Permit Number 2026-P-1786-PP
Job Address: Kimbro Crossing Preliminary Plat, Manor, TX. 78653

The first submittal of the Kimbro Crossing Preliminary Plat (*Preliminary Plan*) submitted by Identity Capital and received on March 13, 2026, have been reviewed for compliance with the City of Manor Subdivision Ordinance 263B.

Kimbro Crossing Preliminary Plans – 6th submittal

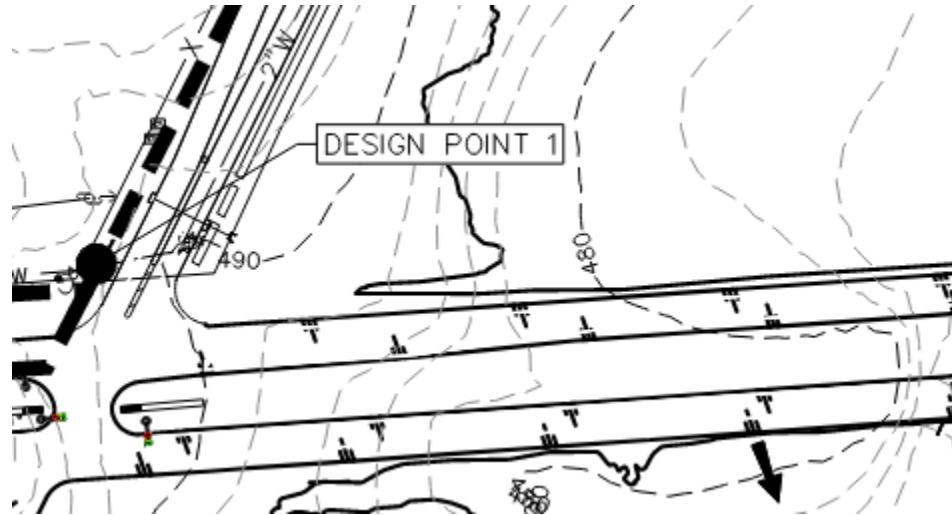
6th Review: Comment remains.

- How is OS DA 20 and Da-19 going to the pond? Seems like this runoff is proposed channel on Lots 2 to 6 Block B. Please confirm this.
- FYI. Lot 1 and 2 Block C will receive about 17.81 acres offsite drainage and appears not to have any preventions for that only to sheet flow the flows.
- Is OS DA18 drainage area coming into your storm system? If so, add a note on your engineering plans for this preliminary plat submittal.
- Any storm sewer line that received off-site drainage is considered a public storm line. Consider adding a drainage easement for any line with that characteristic. This drainage easement(s) can be added later in the process (eg. construction plans).

6th Review: Comment remains.

- Comment C1.0; At Design Point 1 (existing); add a table with the following information:

acres	%	cfs	cfs	cfs	cfs
	Drainage Area	IC	2-yr	10-yr	25-yr	100-yr
POA 1 Existing	X	X	X	X	X	X

- Comment C2.0; At Design Point 1 (proposed); add a table with the following information:

- Use for POA 1 all drainage areas that are going to the proposed detention pond location.
- Seems like that DA 3 (existing) and DA 12 (proposed) are not proposing any proposed IC and they are not going to DA-1. In order to clarify this, add a POA 2 for the comparison of these 2 drainage areas as we mentioned above. Also on C1.0, show the storm sewer structure (if culvert, size and material if bridge, just draw the bridge plan view) that use DA 3 (DA-12) to go under the road.

- After you route your proposed hydrograph through the proposed pond volume and proposed outlet structure for 2-yr, 10-yr-, 25-yr and 100-yr storm events, provide the following table on C2.0:
